DEVELOPMENT REVIEW BOARD REPORT

MEETING DATE: June 23, 2005

CASE NUMBER/ PROJECT NAME	22-DR-2005 Advanced Health Care		
LOCATION	9846 N 95th Street (Lots 2 – 4, Ironwood Square)		
REQUEST	Request approval of a site plan and revised elevations for a new medical rehabilitation facility.		
OWNER	Mountain West Enterprise 435-657-1400	ENGINEER	D & M Engineering 480-350-9590
ARCHITECT/ DESIGNER	Gould Evans Associates 801-532-6100	APPLICANT/ COORDINATOR	Bruce Heywood Heywood Enterprises 801-209-4440

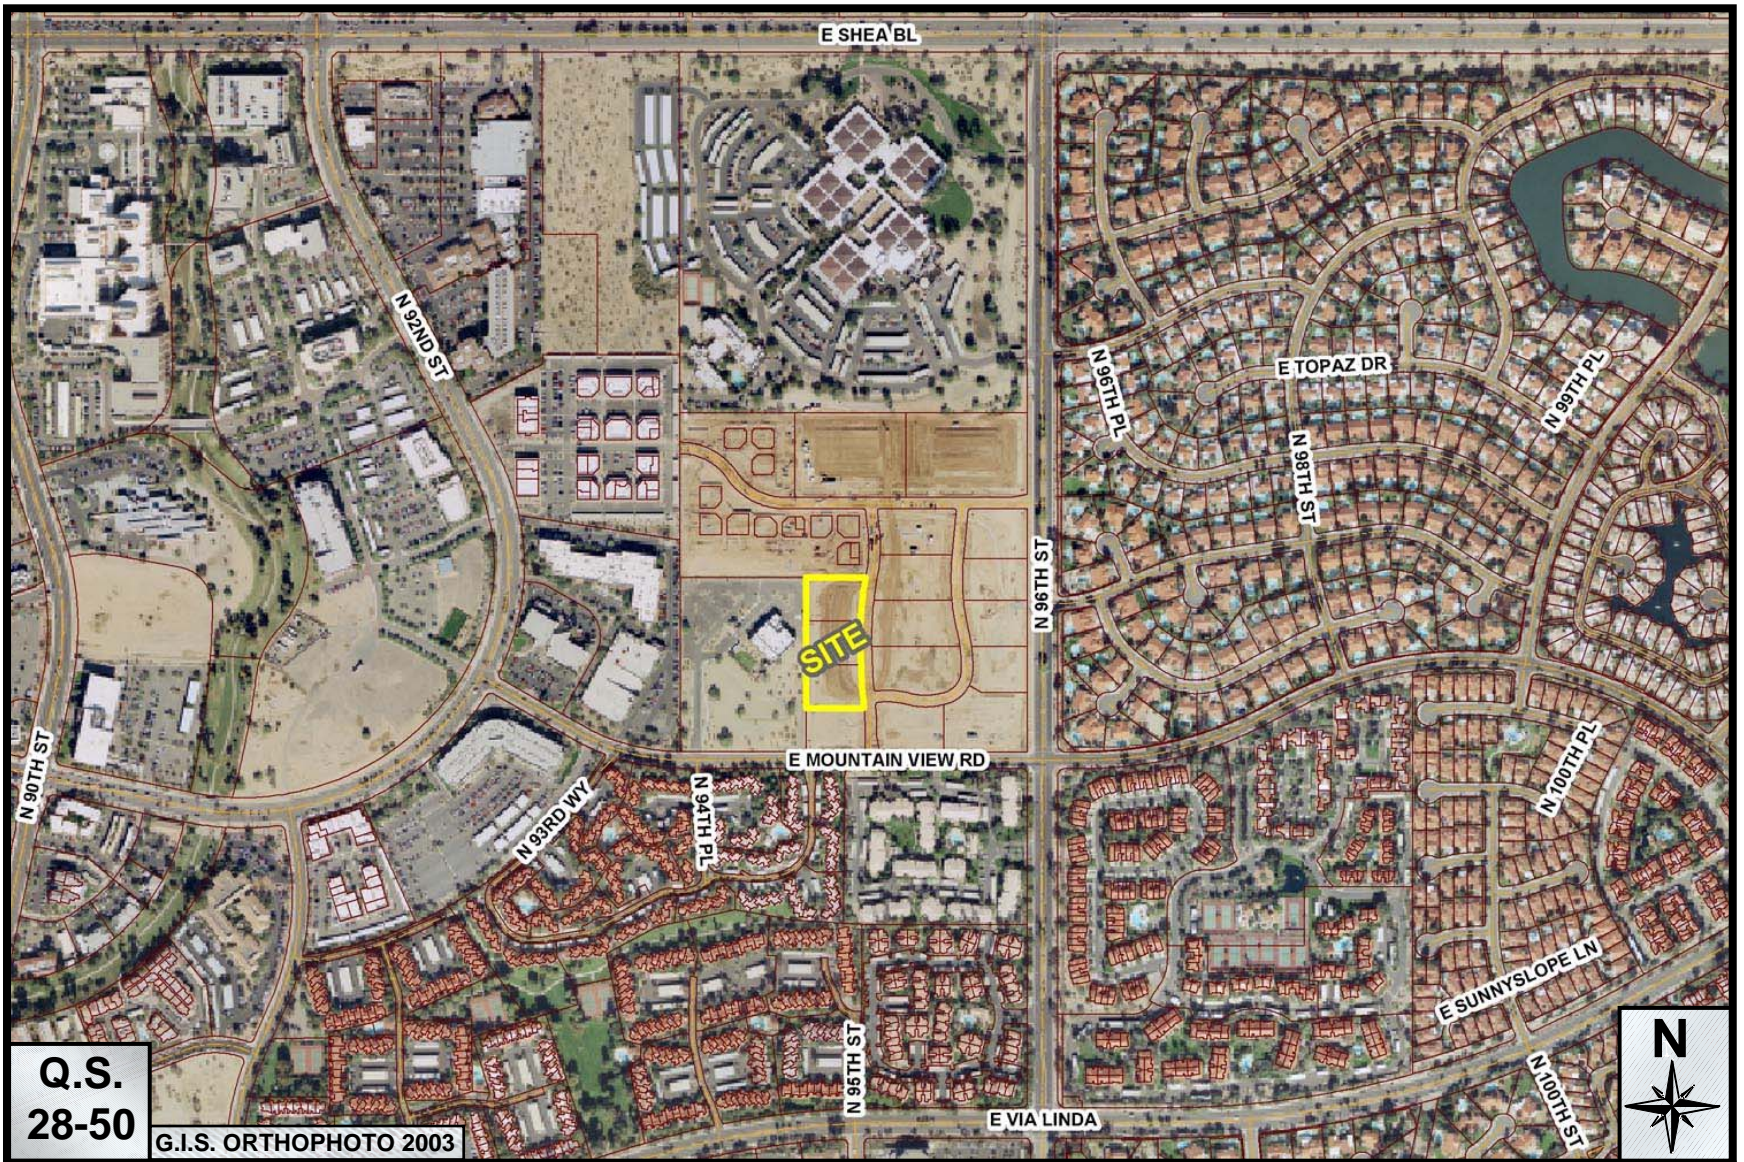
The City of Scottsdale requirement for calculating building height is:

Building, height of shall mean the vertical distance measured from a point of reference elevation established twelve (12) inches above the average elevation at the top of the curb of the street or streets adjacent to the property, or to the top of the crown of the roadway or roadways, if there is no curb, to the highest point of the coping of a flat roof, or to the highest point of a mansard roof or to the highest gable of a pitch or hip roof. In cases where drainage considerations supersede this ordinance, the point of reference elevation would be subject to the approval of the city engineer.

The average elevation of the top of the curb along 95th Street is calculated by averaging curb shots along 95th Street:

$(1,366.71 + 1,366.34 + 1,366.27 + 1,366.19 + 1,365.88 + 1,365.63 + 1,365.43) / 7 = 1,366.06$

Point of reference elevation: $1,366.06 + 1 = 1367.06$

Finished Floor Elevation: **1,367.67**

Highest pitch of the roof: $28.67'$ above finish floor = $1367.67 + 28.67 = 1,396.34$

Building Height = $1,396.34 - 1,367.06 = 29.28$ feet

West Elevation

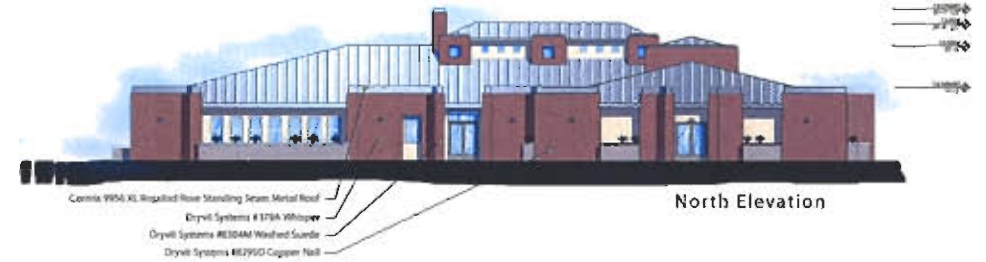
This item was continued at the June 9, 2005 Development Review Board hearing to this date to afford the applicant an opportunity to incorporate the concerns of Board members regarding the “Scottsdale” character of the proposed building. The revisions made to the design, and included herein as **Attachment 5** (site plan) and **Attachment 6** (building elevations), attempt to reflect a more “southwest aesthetic” according to the revised narrative.

Changes made to the design presented on June 9, 2005 include:

- ✓ *Increased height and widths of certain building walls now revised to extend above the roof line;*
- ✓ *Addition of recessed windows*
- ✓ *Change of roofing material from dark colored concrete shingle to light gray standing seam metal*

The elevation drawings as submitted by Bruce Heywood on Friday May 6, 2005 have been revised to include details inspired from Frank Lloyd Wright's Susan Lawrence Dana House, the Ward W. Willits House, and the Frederick C. Robie House. The following modifications were made to the building elevations:

- The roof pitch was lowered from a 4/12 to a 3/12.
- The northern and southern most roof lines were changed from a gable to a hip configuration.
- The roof overhangs were extended.
- Much of the clerestory glass has been deeply recessed into the building.
- Building mass was added between the clerestory glass elements.
- Columns, canopy supports, and the fireplace were given more mass.
- The clerestory elements at each patient wing were combined and organized symmetrically with elements near the base of the building.
- Planter boxes were added to the wall of the building.
- A heavier "base" was incorporated into the design at key locations.
- The constant wainscot was removed.
- The building colors have been modified to have more contrast and richness to them.

- a. Architectural elements, including dimensions, materials, form, color, and texture, shall be constructed to be consistent with the building elevations submitted by GouldEvans with a date provided on the plans by City staff of 6/14/2005.
